January 23, 2023

Re: Variance Requests, 176 Scraggy Neck Road, Bourne (Map 51.0, Parcel 1)

Exhibit A

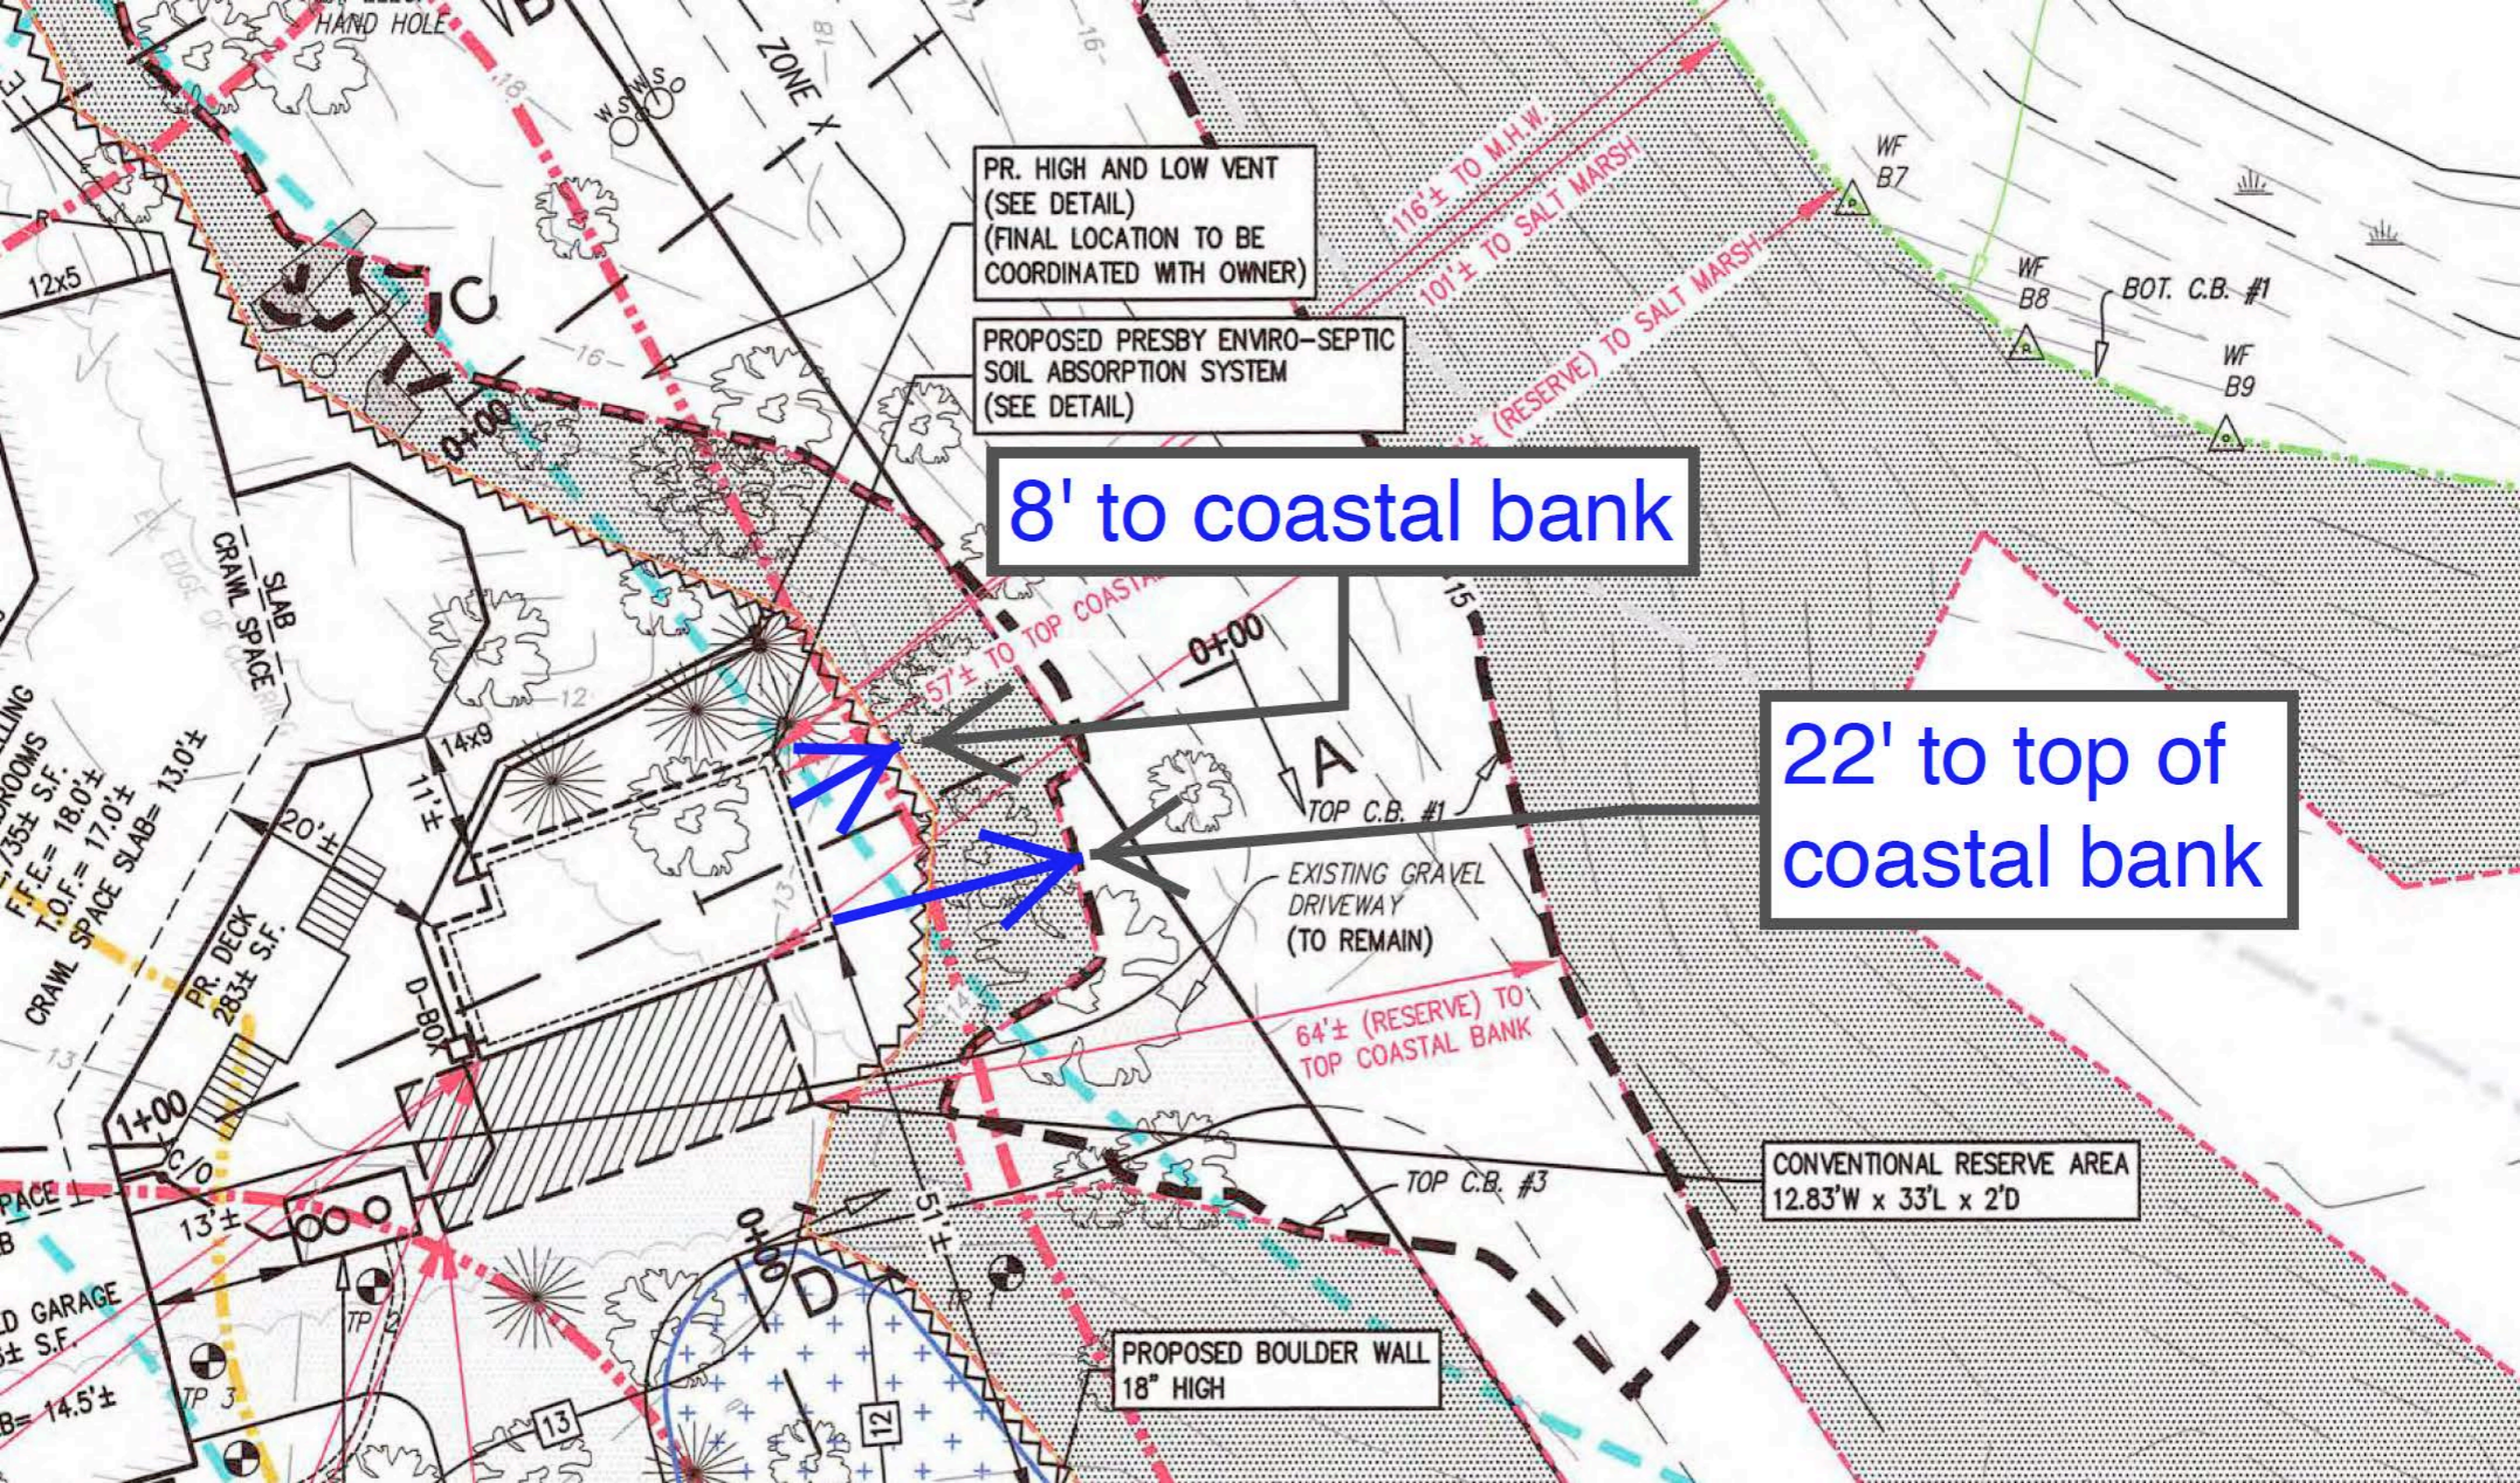
BEI’s variance application is inaccurate and fails to account for all Project impacts, because it does not include *any* setback distances to Coastal Bank #3, which is the closest Coastal Bank to the proposed septic system. To illustrate this deficiency, I have attached a map (Exhibit A) prepared by our expert hydrologist, Scott Horsley, which shows the setbacks from the top of Coastal Bank #3 to the proposed septic system. As shown on Exhibit A, the leaching field is only 8 feet from the bottom and 22 feet from the top of Coastal Bank #3, and the reserve area is even closer. Accordingly, the variances needed and the setback distances listed by BEI in the application are inaccurate, such that Project impacts cannot be assessed by the Board.

Protection Act and Regulations since at least 1978. A Coastal Bank is a “wetland resource” under any recognized definition of that term, even though it is not a body of water. Where the proposed septic system here is only 22 feet from the top of Coastal Bank #3, the proposed Project does not comply with the 150 Ft. Setback Regulation’s mandate that “In no case shall a septic system leaching facility be placed within 75 feet of a wetland.” Accordingly, the Board must deny the variances for the Project.

The Project also requires variances from the state Title 5 regulations, because the proposed septic system is only 22 feet away from the top of Coastal Bank #3. Pursuant to the provisions of Title 5, 310 CMR 15.211(3) for “Minimum Setback Distances”: “All setback distances from wetlands shall be measured in accordance with the criteria of the Wetlands Protection Act and 310 CMR 10.00: Wetlands Protection, from the most landward edge of the following features: ... **top of coastal bank as defined in 310 CMR 10.30(2)**” (emphasis added). This means that under Title 5, a septic system must be located 50 feet from all Coastal Banks, measured from the top of the Coastal Bank. See 310 CMR 15.211(3). Where the Applicant has failed at this point to even acknowledge that Title 5 applies here, and has not applied for any Title 5 variances, we request that the Board reject the current application.
